**9.3 NO. 12 (LOT: 6; D/P: 2360) FLORENCE STREET, WEST PERTH - PROPOSED FOUR GROUPED DWELLINGS**

**RECOMMENDATION:**

That Council in accordance with the provisions of the City of Vincent Local Planning Scheme No. 2 and the Metropolitan Region Scheme, **APPROVES** the application for four Grouped Dwellings at No. 12 (Lot: 6; D/P: 2360) Florence Street, West Perth, in accordance with the plans shown in Attachment 2, subject to the following conditions and the associated advice notes in Attachment 7:

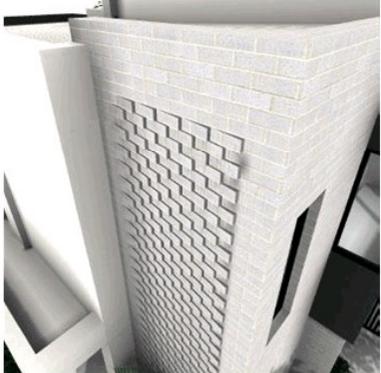
Comments Received in Objection:	Administration Comment:
<p><u>Visitor Parking</u></p> <p>Visitor parking in the front setback does not reflect predominate features of the streetscape character.</p>	<p>The location of the visitor bay is compliant with the R Codes Volume 1. Notwithstanding this, an analysis of the street context found car parking within the street setback is a predominate feature. Landscaping between the visitor bay and Unit 1 is required through the detailed landscape plan to soften the visual impact on this dwelling. Furthermore, sufficient landscaping is provided to soften with visual impact on Florence Street with four new trees provided within the street setback area.</p>
<p><u>Non-compliant development</u></p> <p>Proposed development doesn't comply and therefore should not be supported.</p>	<p>The applicable planning policies are intended to be applied flexibly opposed to rigid compliance with deemed-to-comply criteria provided design principles and objectives are satisfied. Deemed-to-comply criteria is the minimum applicable standards, where a development meets the 'deemed-to-comply' requirements this provides a straight forward pathway to approval.</p> <p>A proposal is required to demonstrate compliance with design principles and/or objectives where it does not satisfy the corresponding deemed-to-comply provisions, subject to the discretion of the delegated decision maker being the City of Vincent Council in this instance.</p>

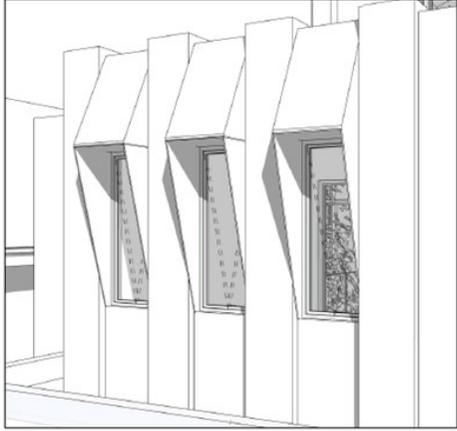
Comments Received in Objection:	Applicants Comment:
	 <p data-bbox="1146 774 1541 829"><b>MODERN TAKE ON TRADITIONAL AWNING / WINDOW CANOPY</b></p>

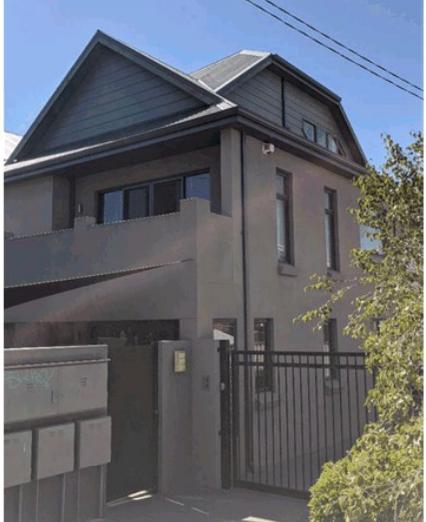
Comments Received in Objection:	Applicants Comment:
	 <p data-bbox="1115 890 1704 912">76 Carr St: In line with rear of 12 Florence St – two lots away</p>

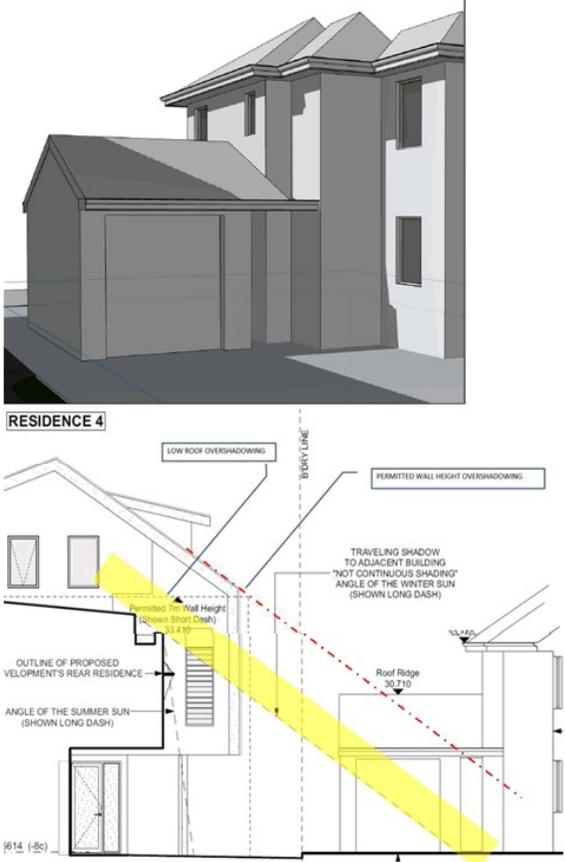
Comments Received in Objection:	Applicants Comment:
	<p>terraces that can intrude on neighbours have further screening to comply for overlooking. In researching other existing neighbouring buildings in the precinct we have not identified many examples where the design of dwellings seeks to integrate visual privacy as structurally as this proposal.</p>

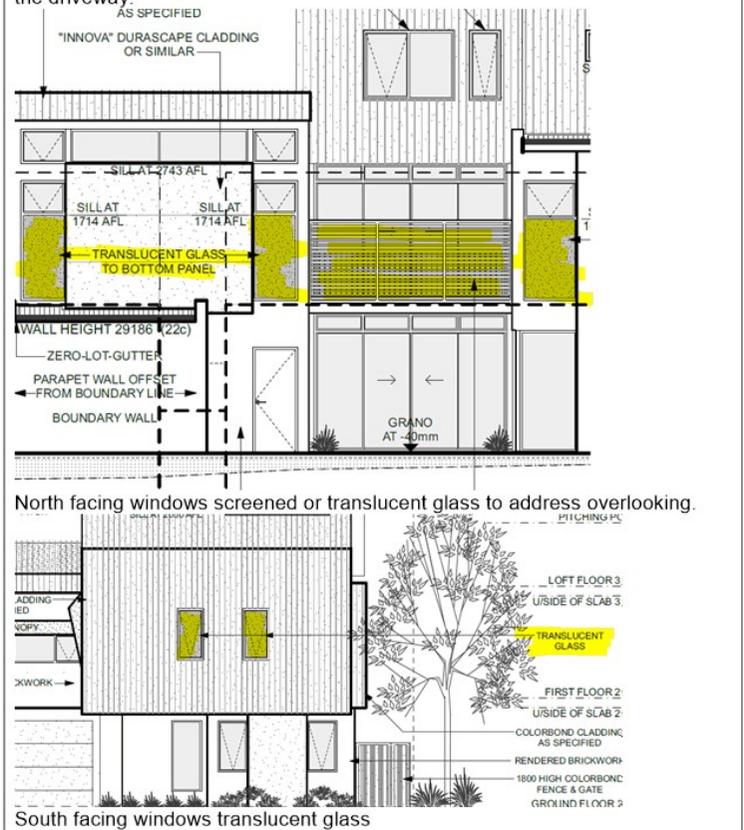
Comments Received in Objection:	Applicants Comment:
<p>at 14 Florence Street and overlooking south towards 10 Florence Street dwellings.</p> <ul style="list-style-type: none"> <li>Reduced privacy of 16 Florence Street and dwellings fronting Janet Street.</li> </ul>	<p>North aspect windows and terraces include screening. We understand that this includes future lot 7C kitchen and lot 271A outdoor living area.</p> <p>There are limited windows looking south and these are set back by the width of the driveway.</p>  <p>North facing windows screened or translucent glass to address overlooking.</p> <p>South facing windows translucent glass</p>
